Response to NRC Review Questions

LaCrosse Boiling Water Reactor
Dairyland Power Cooperative
Genoa, Wisconsin 54632

Re: Response to NRC Review Questions

We are submitting ten copies of the report "Response to NRC Review Questions, Seismic Hazard and Liquefaction Potential at LACBWR Site, near Genoa, Vernon County, Wisconsin" for your use. This report contains answers to all the questions raised by the Nuclear Regulatory Commission (NRC) in their letter of April 25, 1980, to Dairyland Power Cooperative (DPC).

FIGURE 1
WISCONSIN ARCH SEISMOGENIC ZONE

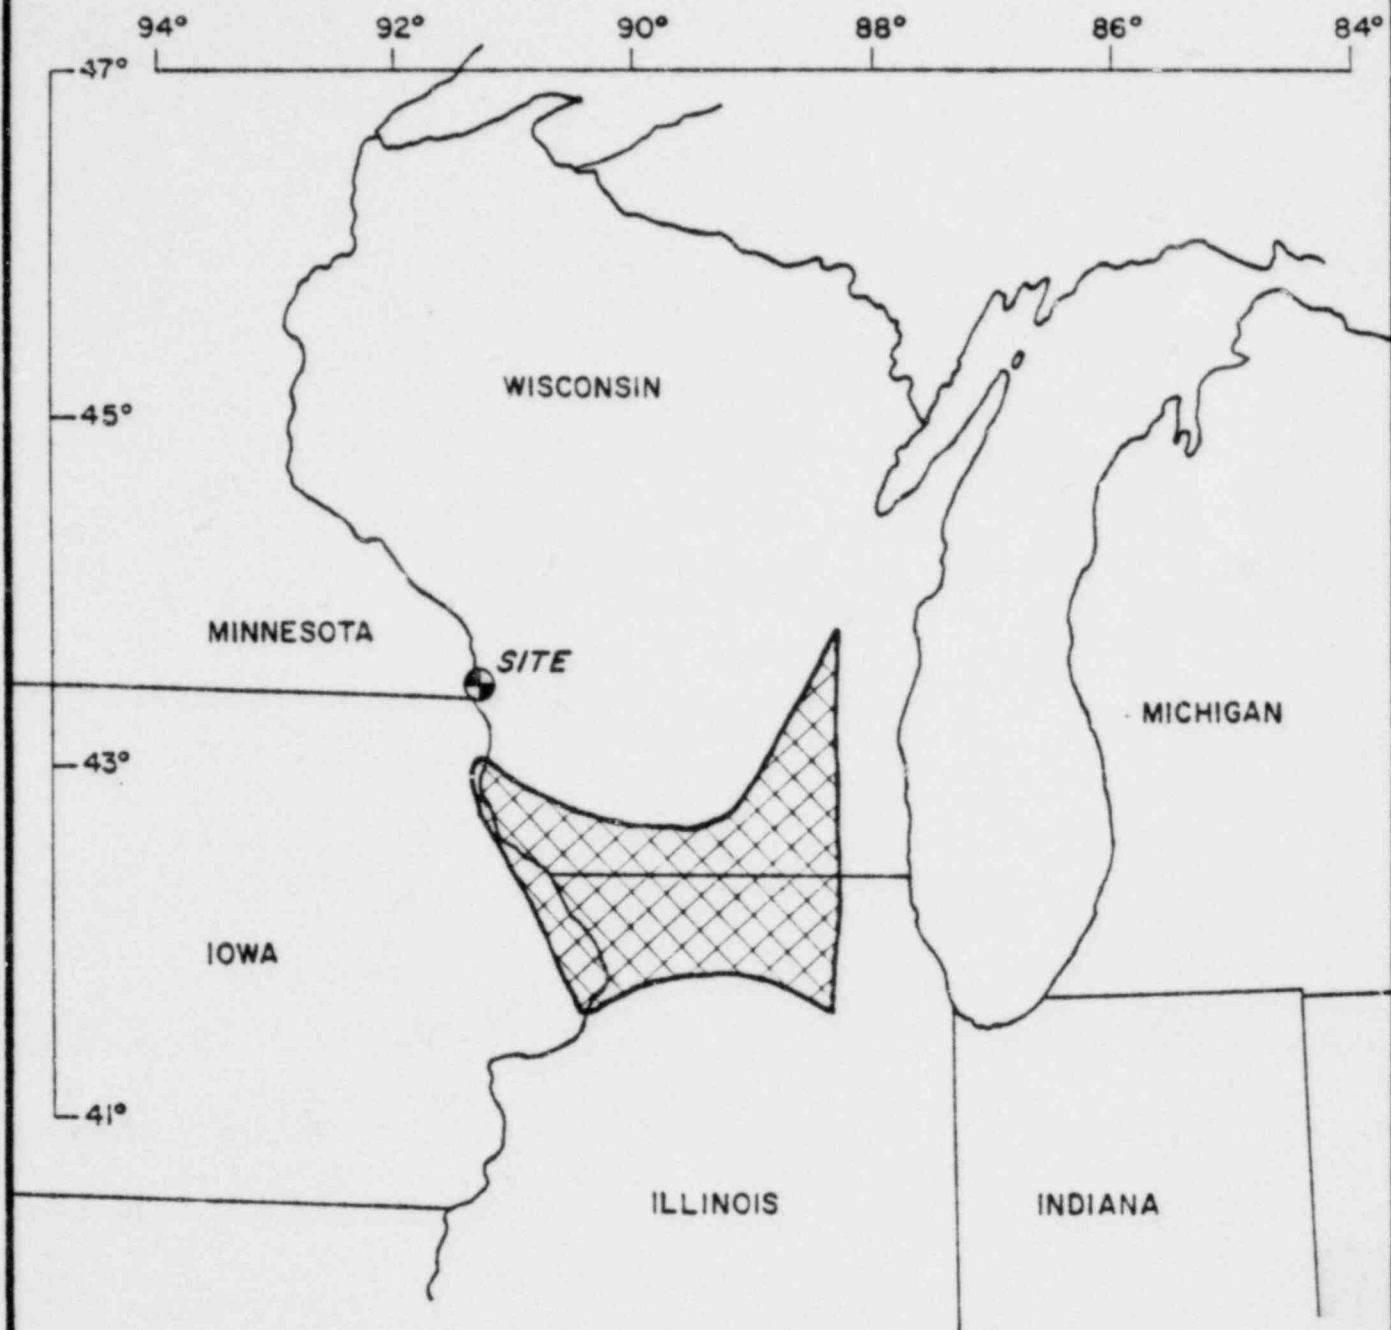
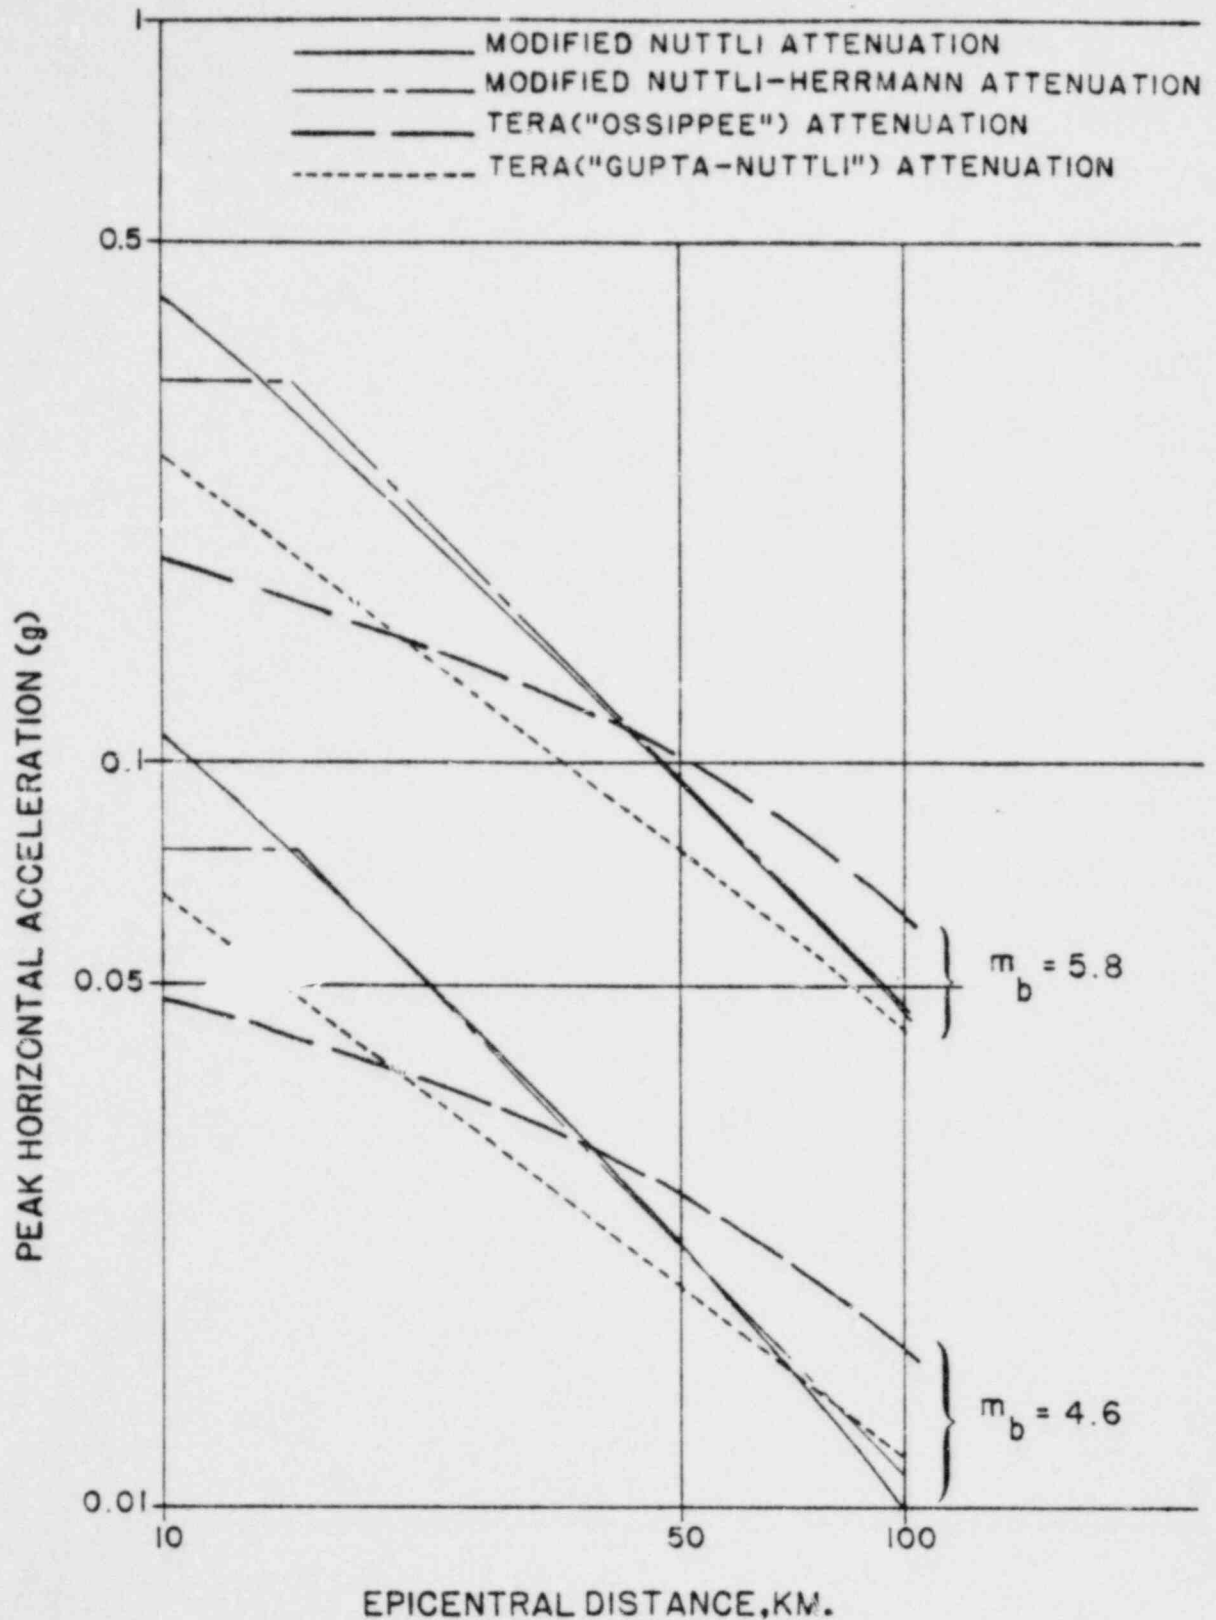
6. Provide data to substantiate that the effect on an oiled rope is to increase (sic)* N by 20%.
 7. The Response has characterized the SSE as corresponding to a "very low seismic risk." Accordingly, the Response states that "using the designated seismic parameters should lead to conservative conclusions." In view of the implications in your response that margin may exist relative to the existing specification of the SSE, investigate whether a lower SSE may be justified and if so, provide the basis for such a position.

Mississippi River arch (see Figure 1). The area of this zone includes the larger historical events which have been reported in northern Illinois and southern Wisconsin. The delineation of this zone (Figure 1) is somewhat different from that suggested by Nuttli and Herrman (1978), but this difference is immaterial for the present study.

This acceleration is plotted as a function of distance for several values of m_b in figure 2.
